VOLVO

WORKSHOP BULLETIN

| HANDBRAKE | P |

Improved handbrake, 140, 164 and 1800

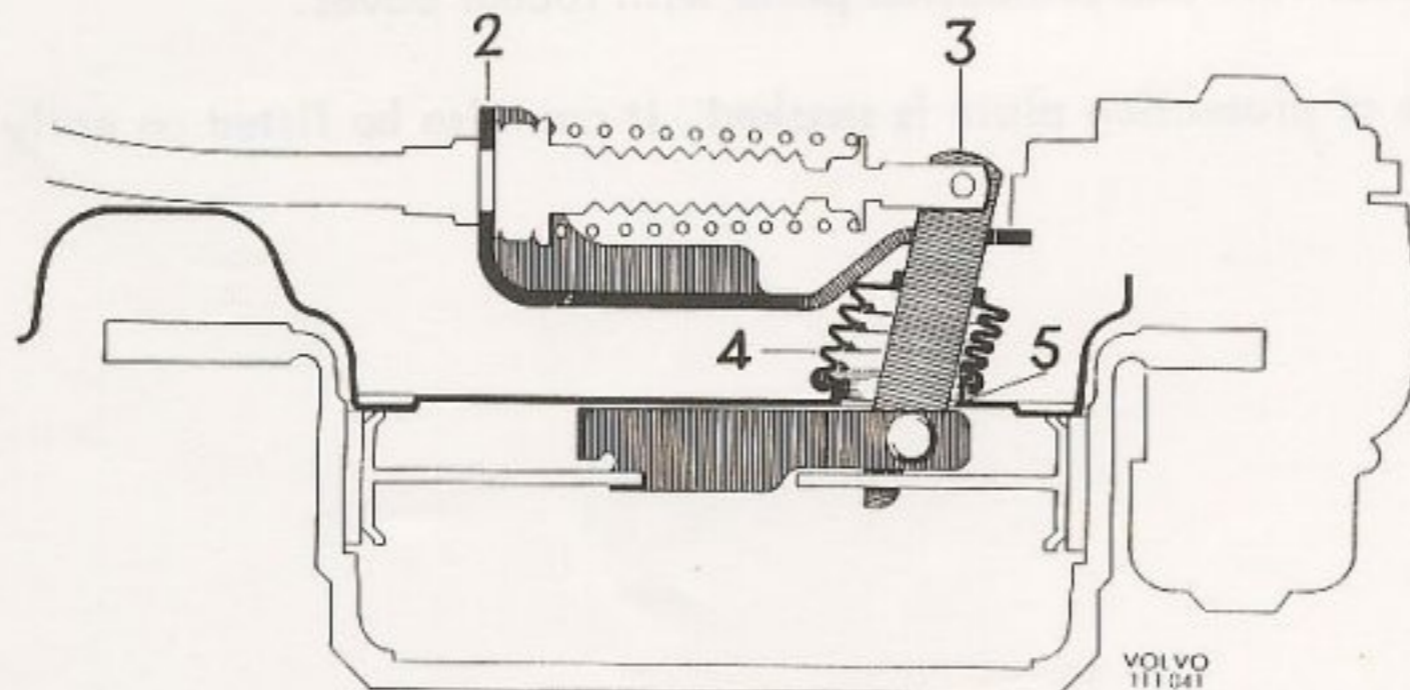
The following modifications have been made concerning the subject handbrake.

1. New type of pawl and ratchet segment on the 140 and 164.
2. New type of bracket for cable.
3. Lever with larger movement.
4. Rubber cover for lever introduced and cover plate removed.
5. Guard plate with attachment for rubber cover.

2. Bracket

3. Lever

4. Rubber cover

5. Guard plate
